SITE ISSUE PROPOSED REPAIRS TO THE TIMBER FRAME

FOLLOWING REMOVAL OF CEMENT RENDER

The Limes, Rectory Road, Bacton, Stowmarket, IP14 4LE

DWG 225/RR06

South West Elevation

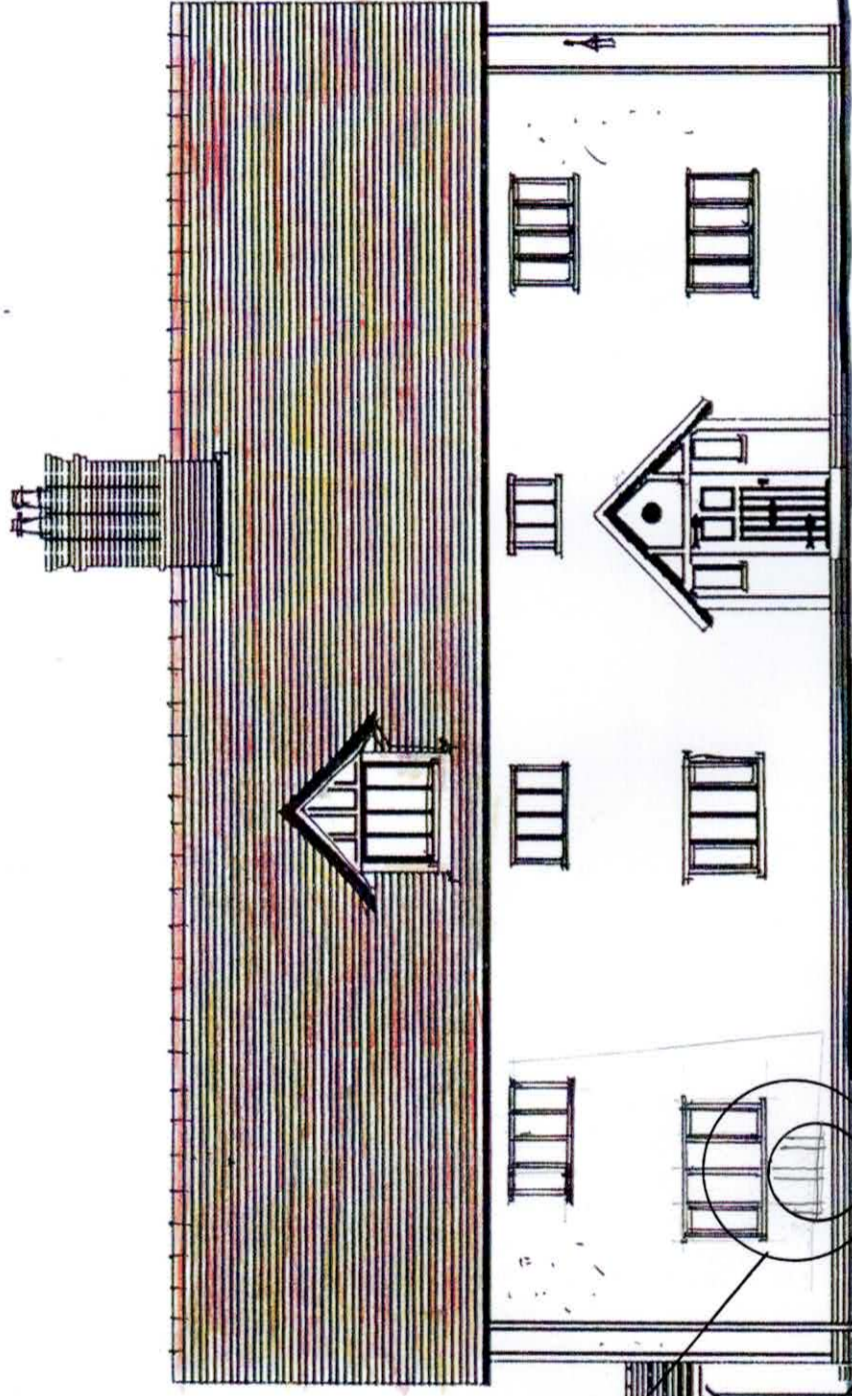
REPLACE SECTIONS OF SOLE PLATE AND UPRIGHTS WITH RECLAIMED SEASONED OAK
